SUBJECT: Michigan Department of Environmental Quality Comments for Operable Unit 5 (OU5) Allied Paper, Inc./Portage Creek/Kalamazoo River Superfund Site, Area 4 Draft Supplemental Remedial Investigation (SRI) Report, dated September 2, 2016, Prepared by Amec Foster Wheeler, Environment & Infrastructure, Inc.

MDEQ's Comments on the DRAFT SRI Report, Area 4, OU-5 Kalamazoo River Superfund Site (09/09/2016)

Comments on Remediation Footprint for Floodplain Soils

Figure 1: Total TEQ as Function of Total PCB

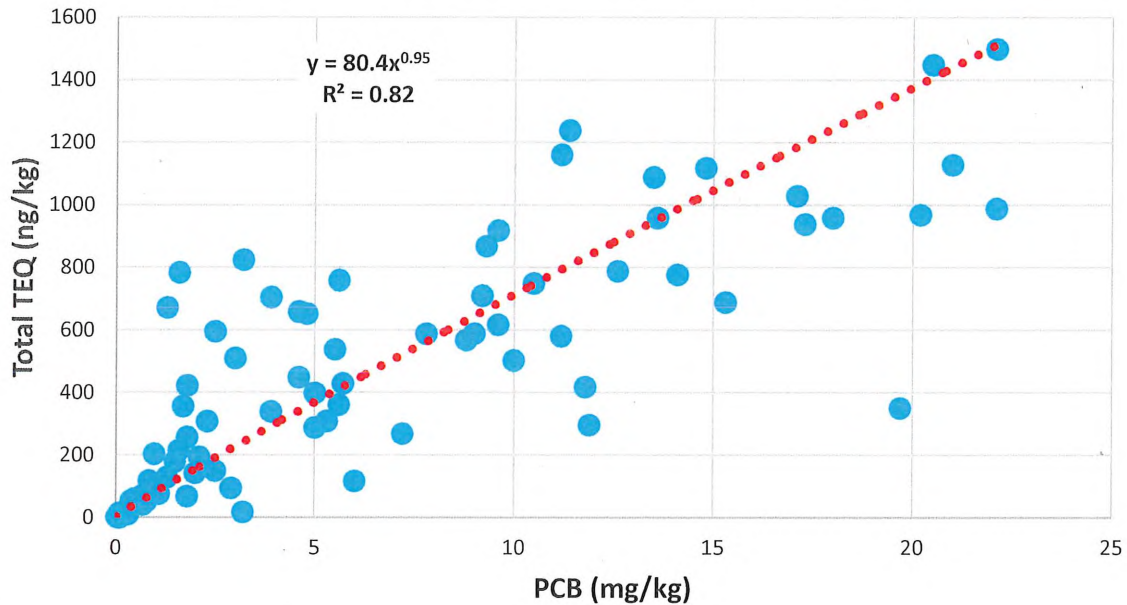
4. MDEQ analyses (detail in attached appendix materials) indicate that there are reasonably reliable correlations between D/F TEQ and total PCBs and with tTEQ (Figures 1 and 2). These correlations indicate that a statistically-based footprint could be developed that leverages the relationship between PCB and TEQ (D/F, DLC and tTEQ) with rigorous propagation of uncertainty in TEQ mapping. Maps would show probability of exceedance of specified TEQ thresholds as contours. These probabilities would account for the uncertainty in the PCB--TEQ relationship, so varying levels of conservatism could be considered as needed. The approach would leverage the cross-autocorrelation between PCB and TEQ to develop the mapping. There are relatively rigorous ways to do this as a multiple variable geostatistics analysis. An illustration of uncertainty (Figure 3) shows that at a PCB concentration of 11 mg/kg, tTEQ could be as high as 663 ppt (95% UCL) above a best estimate from the regression of 164 ppt.

Figure 3: tTEQ Uncertainty

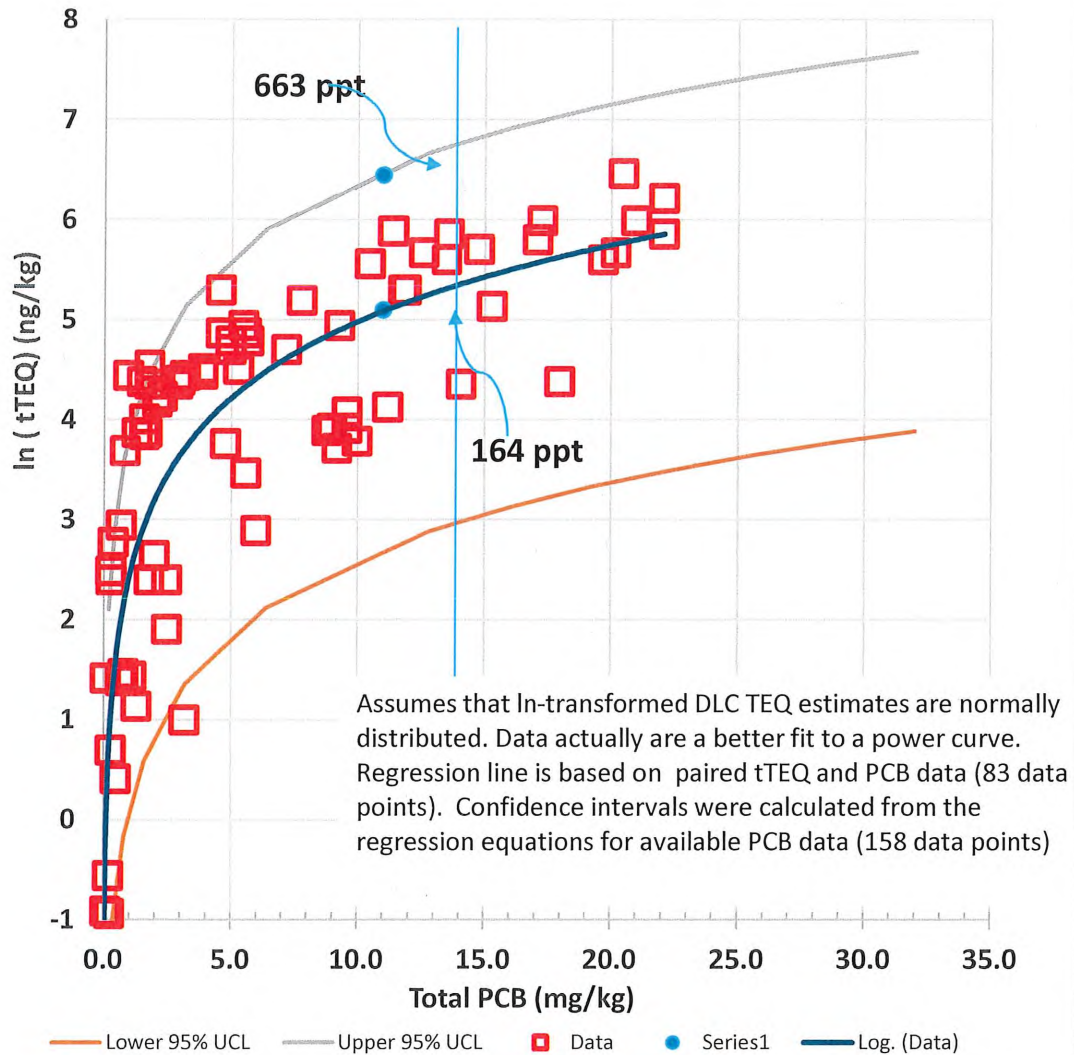
Regardless of the method ultimately selected, a more rigorous approach is needed to determine if the 11 mg/kg PCB footprint will be sufficient to address tTEQ in soil, and whether current data are sufficient for spatial characterization.

**Figure 4: SPATIAL DISTRIBUTION OF PCB AND tTEQ IN
AREA 4 FLOODPLAIN
TARGET TEQ = 120 PPT**

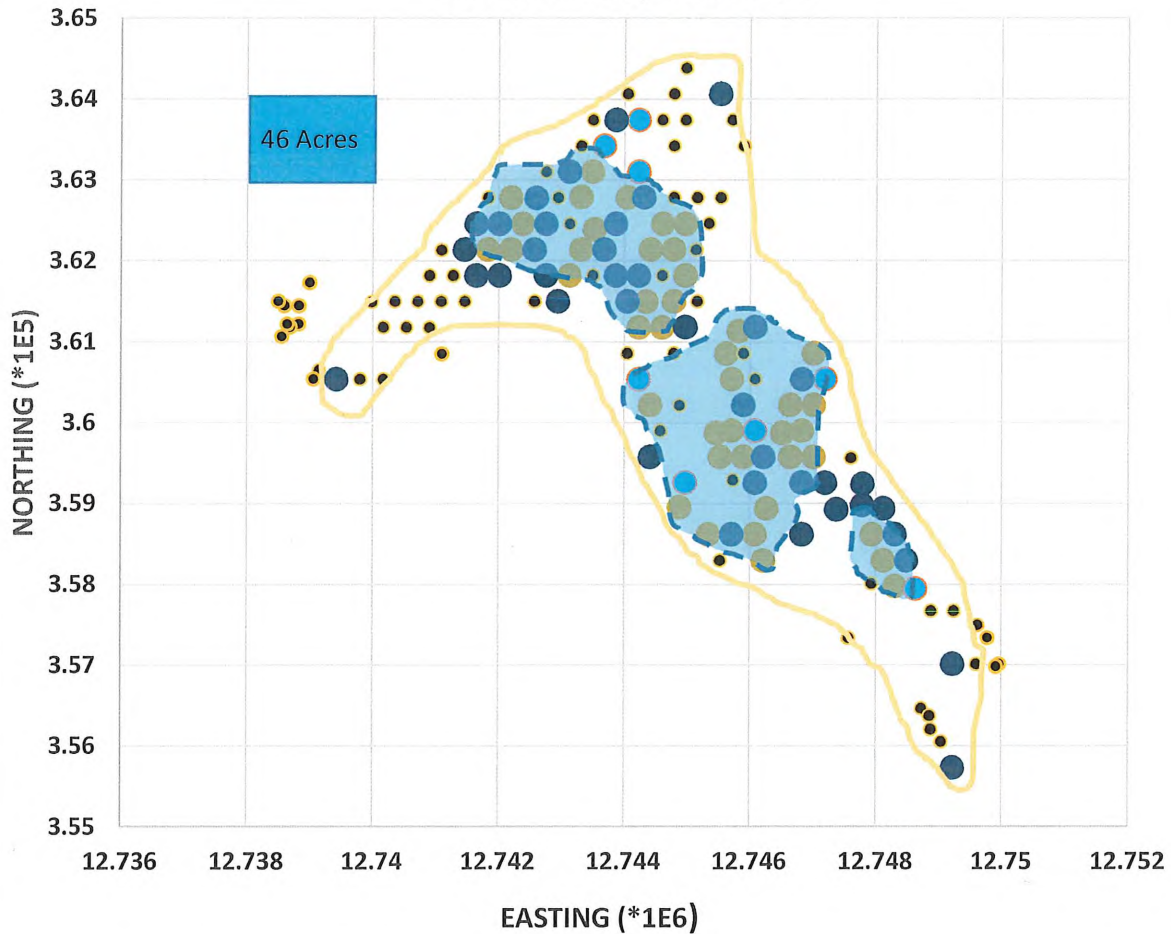
attached graphics, the 11 ppm PCB footprint would not capture ecological tTEQ RALs of 120 (Figure 4) and 200 ppt (Figure 5). These RALs are not suggested as appropriate for Area 4; such values have been used for tTEQ (mainly D/F TEQ) contamination in upland soils at other sites. RALs will be developed as part of further consideration of ecological risks. Also, note that the lines showing extent of area for risk management in these figures have no statistical significance and are used only as a general illustration. MDEQ recognizes that a home range analysis will be performed as part the FS.

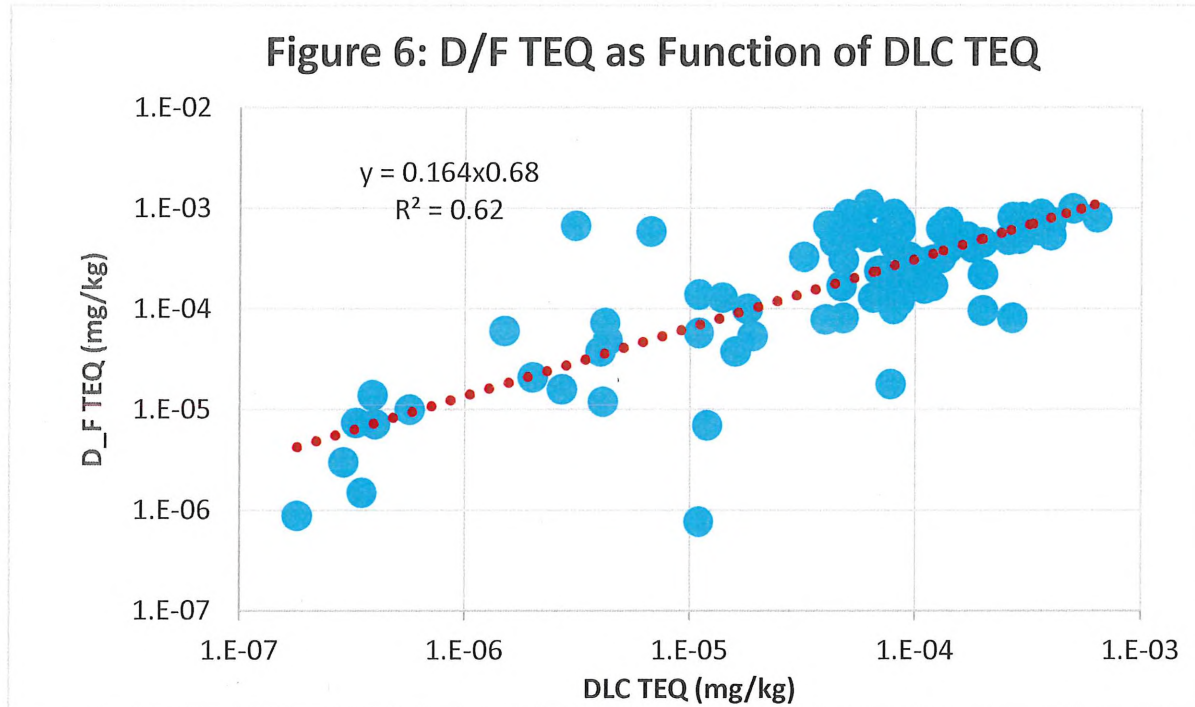
The plot (Figure 6) of D/F TEQ versus DLC TEQ suggests a reasonably consistent relationship, also best estimated, based on R^2 , with a power function which accounted for over 60 percent of variability. The power function was used in calculations that follow. The relative contribution of D/F TEQ to tTEQ is about 75% over the range of PCB concentrations observed in the available dataset.
